**Responses to Comments Made at the December 20, 2001  
Public Hearing Held by the Oxnard Planning Commission**

1. ENVIRONMENTAL IMPACT REPORT (EIR 00-3), for the RiverPark project. The RiverPark project is a 700-acre master-planned community consisting of various commercial, entertainment, residential, public, institutional and open space land uses. Reclamation of the existing sand and gravel site would be included as a component of the overall project. The RiverPark Specific Plan area is located in the northern portion of the city and is generally bounded by the 101 Freeway, Vineyard Avenue and the Santa Clara River. Filed by RiverPark Development, LLC, 304 South Broadway, Suite 400, Los Angeles, California 90013.

FIGURE **3-1**

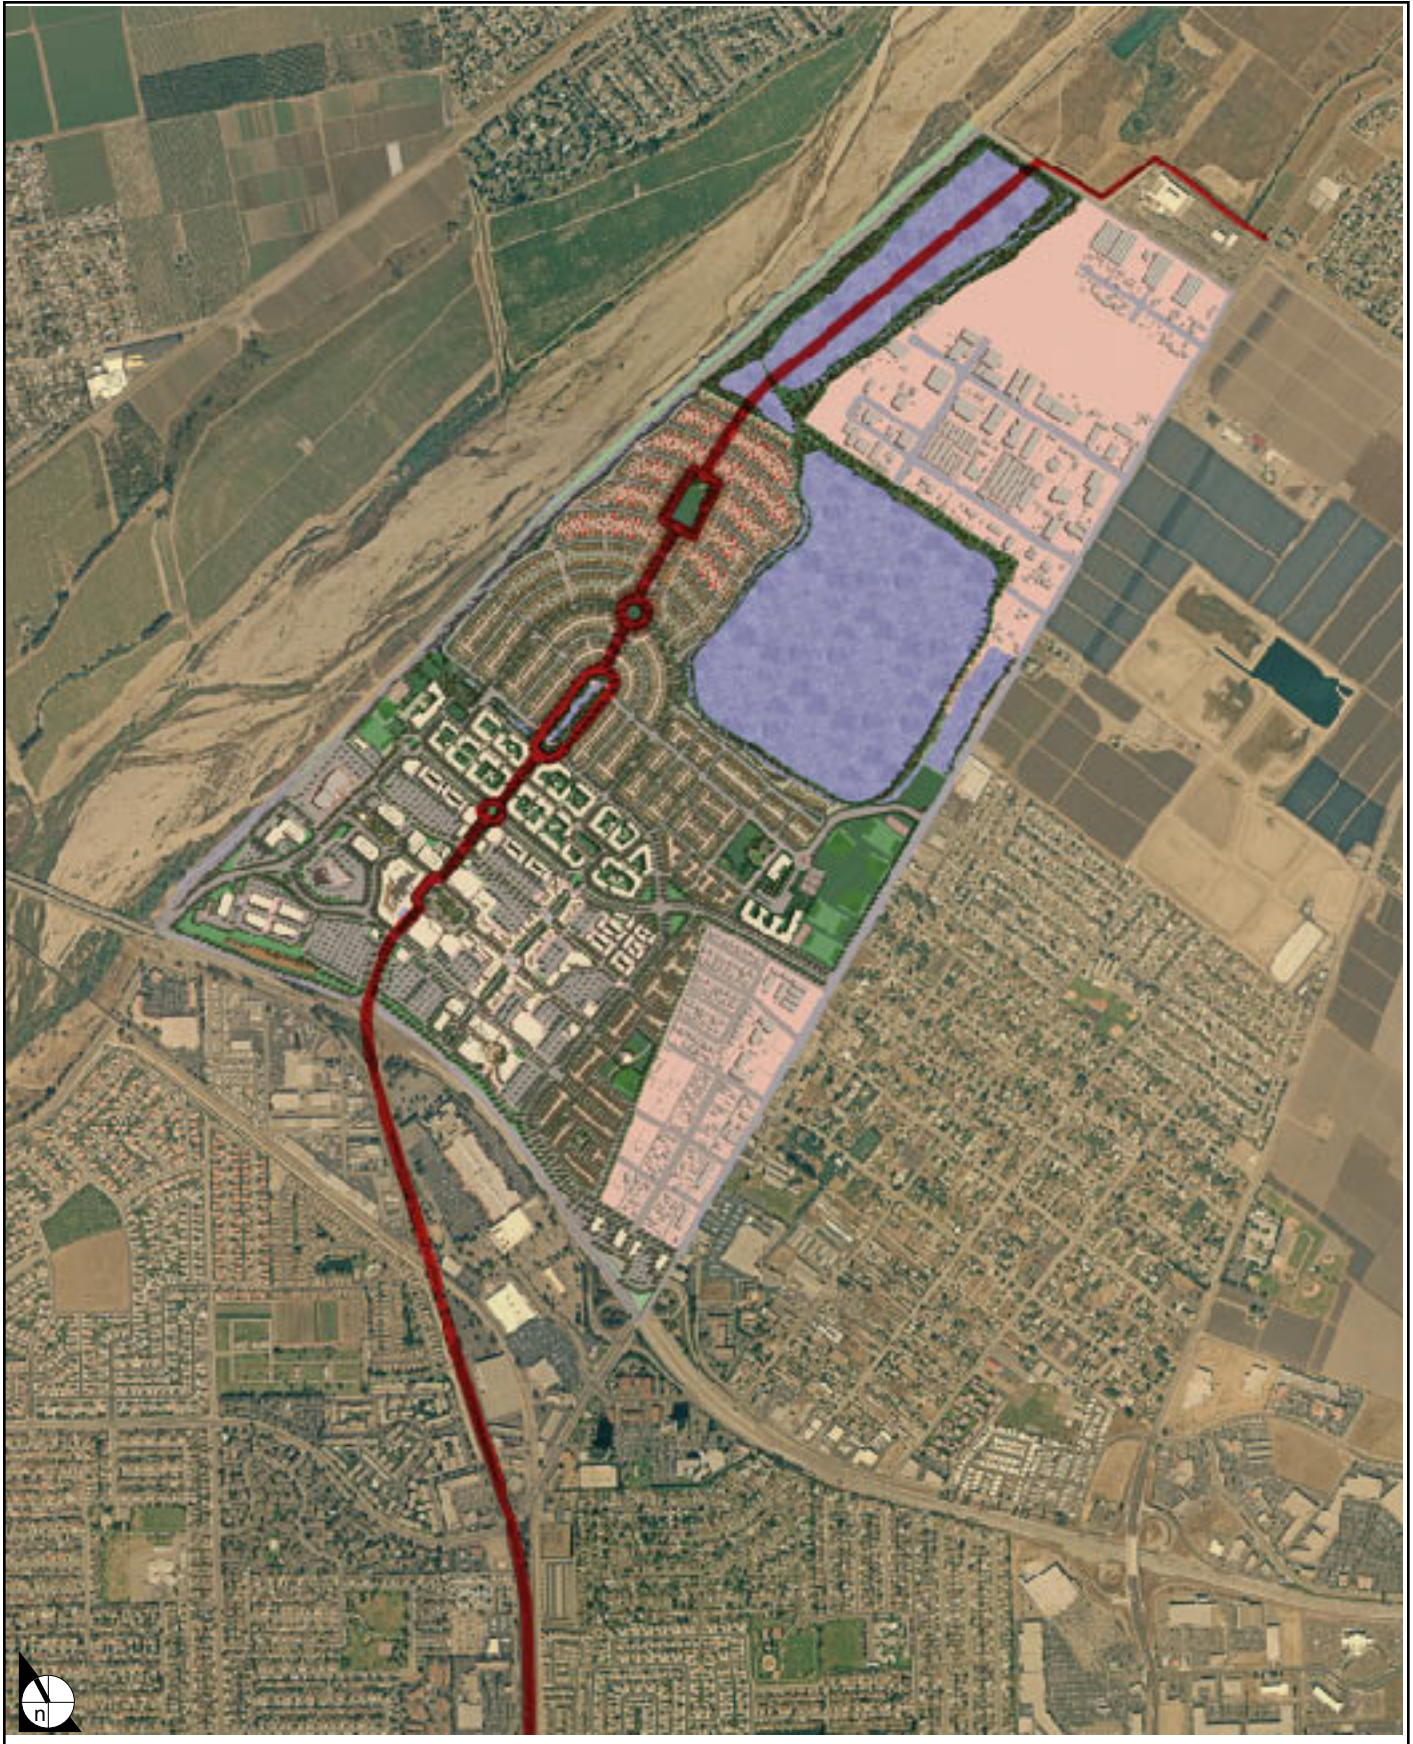
Chairman Duff was concerned about Ventura Road as a major access, as it is subject to serious flooding from the bridge down to the railroad bridge due to the road being in the flood plain of the river. Some work needs to be done to show realignment of the road, or something to preclude flooding where access is not dependent upon to get to this site. Perhaps the plans showing the widening of the bridge over the Santa Clara River or the extension of Oxnard Boulevard would address this problem. Some discussion should be included in this document to say something about the existing situation and how it will be mitigated. Vineyard Avenue is a state highway with 3 points of access proposed into this site from Vineyard including Stroube, Myrtle, Collins, or Walnut, and with the projection of Oxnard Boulevard into this area which does not go anywhere, but stops in the project site, some alignment studies could be done taking Oxnard Boulevard all the way through this project to Central, which is an access road that goes all the way to Highway 101, and might bring about some relief on the existing Highway 232. Right now, Oxnard Boulevard comes over Highway 101 and stops in this development, so all the traffic generated by this project would access out to Highway 101 onto Vineyard. We already have a significant concern of traffic on Vineyard. He asked for additional information in this document showing route alignment with options for Oxnard Boulevard through this project. Take a look at alignment of Oxnard Boulevard that would provide relief in this area.

Burdulis asked about the extension of Oxnard Boulevard past Montgomery around Central which seems to be a good alternative for traffic flow congestion. Further traffic analysis is needed. | JB-2

With regard to traffic impacts on Vineyard Avenue, **Figure 3-1** (following this page) shows the projected traffic conditions with traffic from the project in the year 2020 for the eight signalized intersections along Vineyard Avenue between the Ventura Freeway and Los Angeles Avenue. As shown, all of these intersections will operate at Level of Service C or better. The extension of Oxnard Boulevard to Central Avenue is not required, therefore, to maintain an acceptable level of service on Vineyard Avenue or any other streets in the area.

The extension of Oxnard Boulevard north to Central Avenue is also not considered feasible. Any extension of this road to the north would need to travel through the existing Large Woolsey mine pit, as shown in **Figure 3-1** (following this page), which occupies all the area between the Santa Clara River Levee and the existing Beedy Street and Montgomery/Lambert Street industrial areas. This existing mine pit would need to be completely filled to accommodate an extension of Oxnard Boulevard to the north. Approximately 2.9 million yards of earth material would be needed to fill this pit. Sufficient fill material is also not available to fill this entire pit on the project site. The proposed grading plan has been carefully developed to not require any import of earth materials and create suitable grades to provide for adequate site drainage. If the Large Woolsey pit is filled, the fill material needed would need to be purchased and imported.

Extension of Oxnard Boulevard to Central Avenue would also result in some increase in through traffic through RiverPark. This impact would be more pronounced in the residential neighborhoods in the northern portion of the site. Given that Vineyard Avenue will operate at an acceptable Level of Service C or better, it would be preferable to keep through traffic on Vineyard rather than impacting the character of planned commercial and residential districts planned in RiverPark. As discussed above, Oxnard Boulevard is not designed as a through street but instead as a community collector. With the number of intersections and amount of cross traffic, Oxnard Boulevard would not be an attractive alternative to travel on Vineyard Avenue for through trips to Central Avenue.
